ATTACHMENT 5A

Emergency Plan Marked-up Pages – LaSalle Station

Exelon Standardized Emergency Plan EP-AA-1000
and
Emergency Plan Annex EP-AA-1005

Figure B-1b: Emergency Onsite Organization

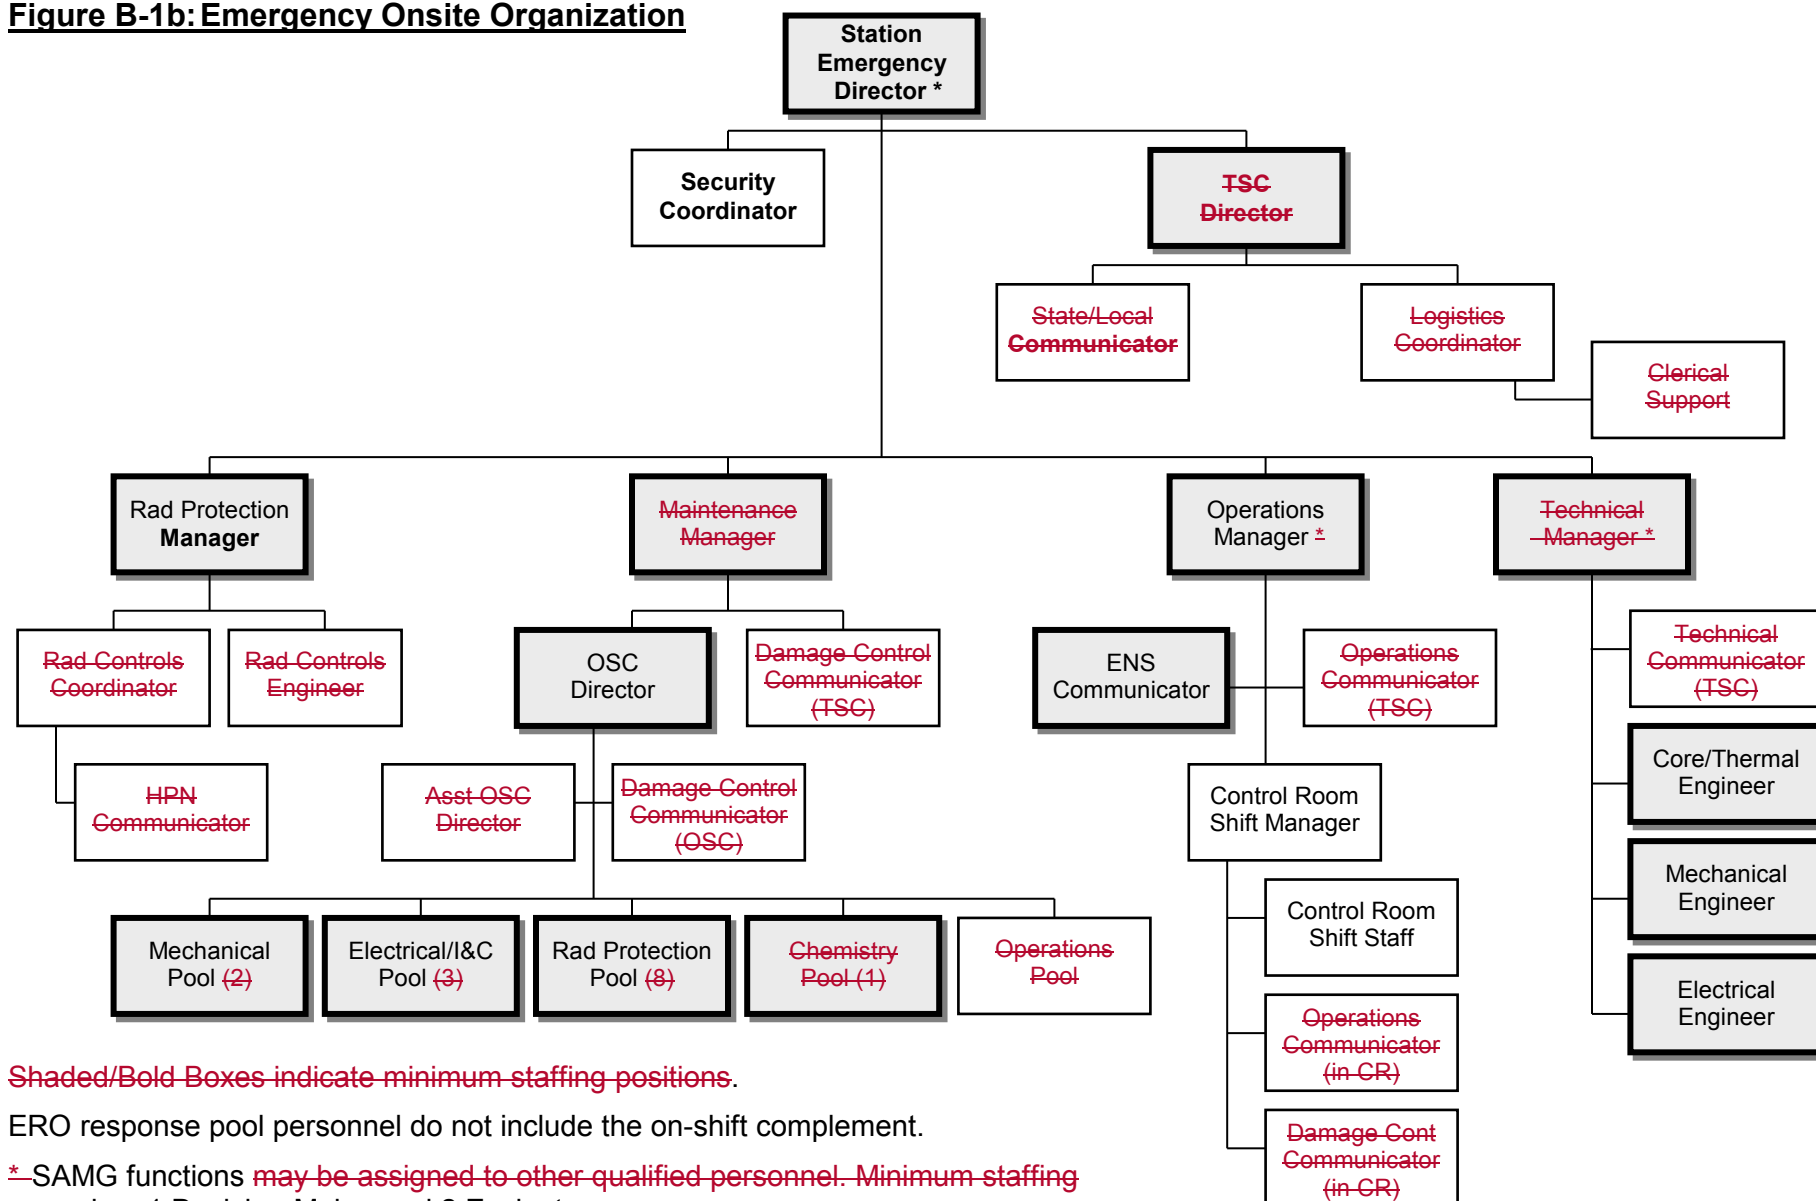
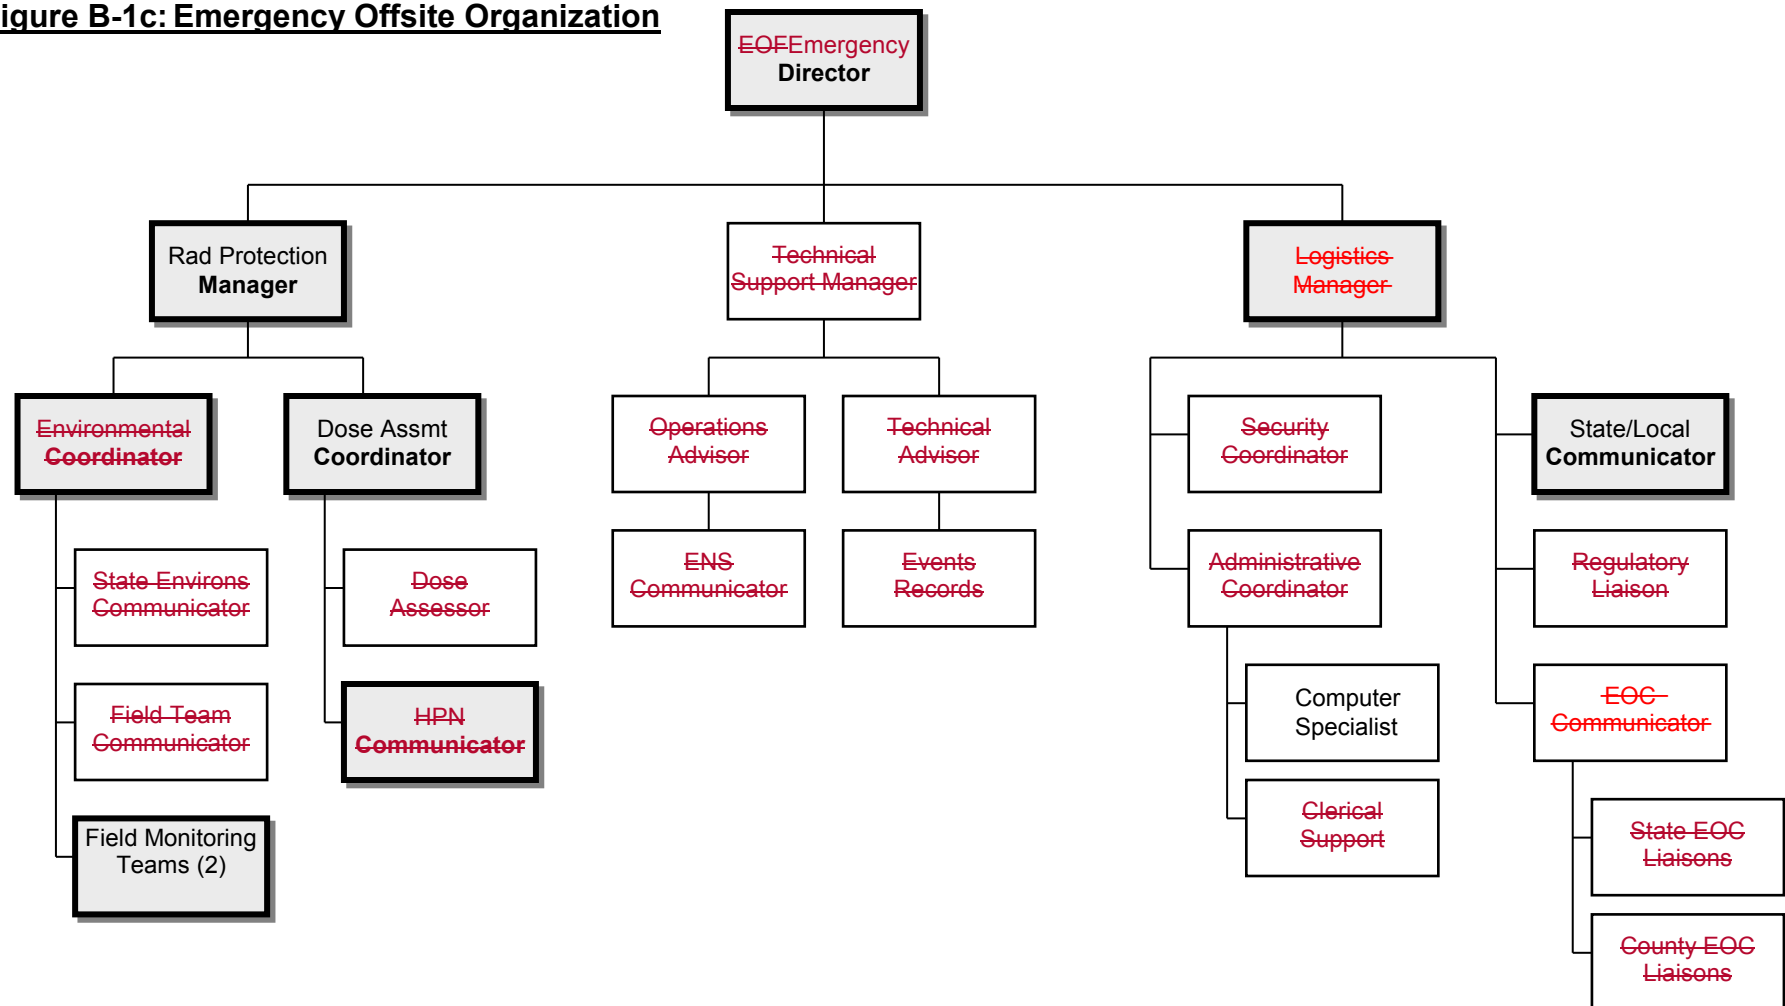
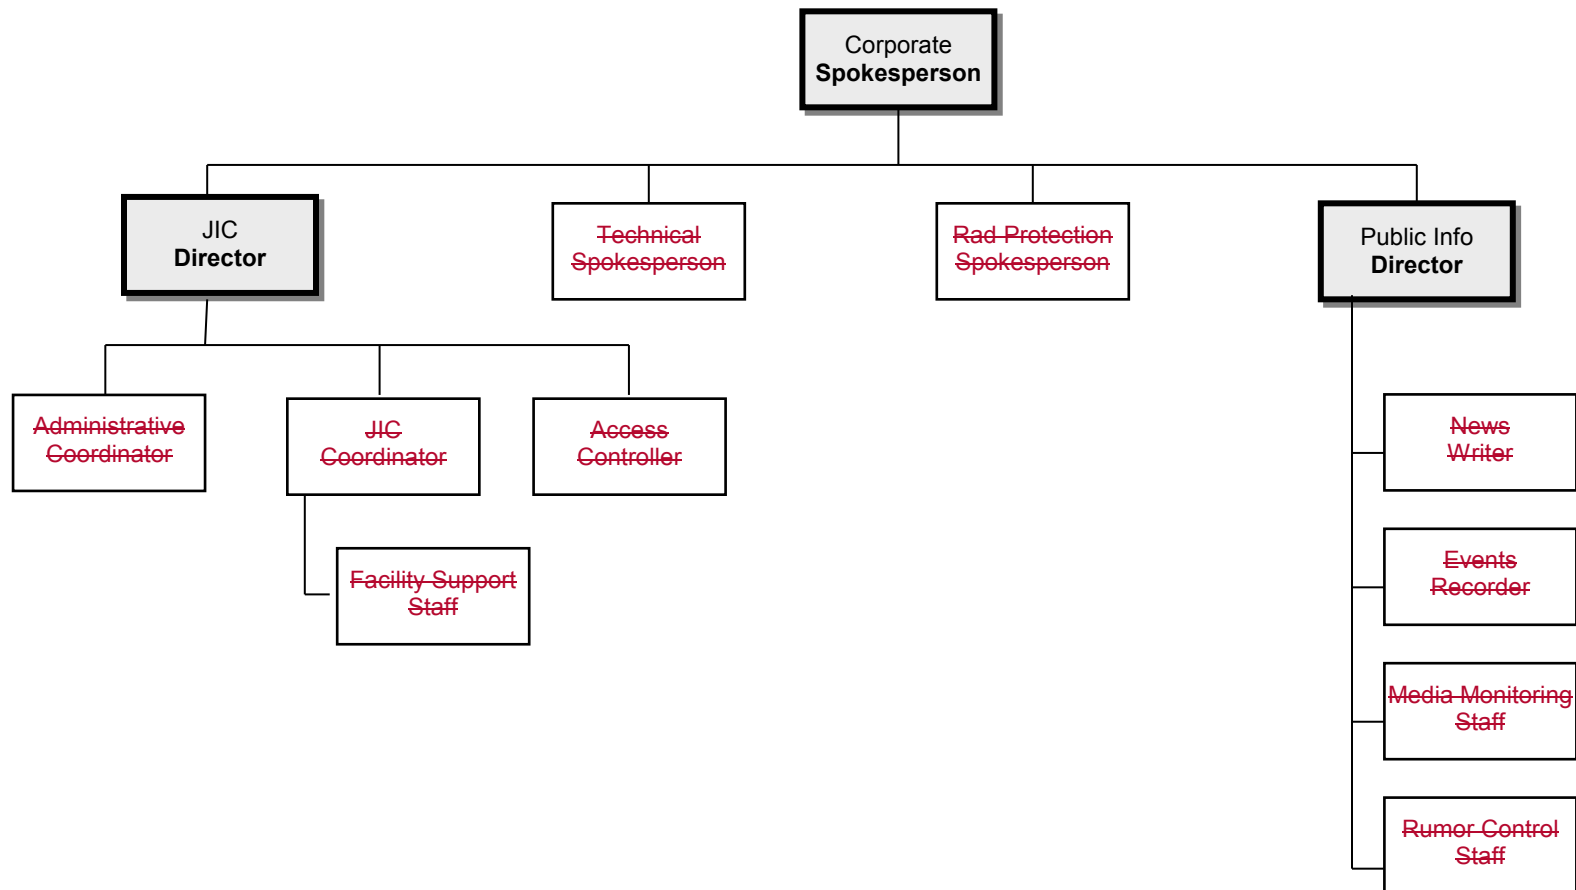
ERO staffing tables contained ~~within the station specific Annexin Appendix 5,~~ lists the key positions of the ERO ~~and the supporting positions assigned to interface with federal, state, and county authorities.~~ Figures B-1a through B-1d illustrates the overall emergency response organization. Section B.5 discusses specific responsibilities and the interrelationships for key positions.
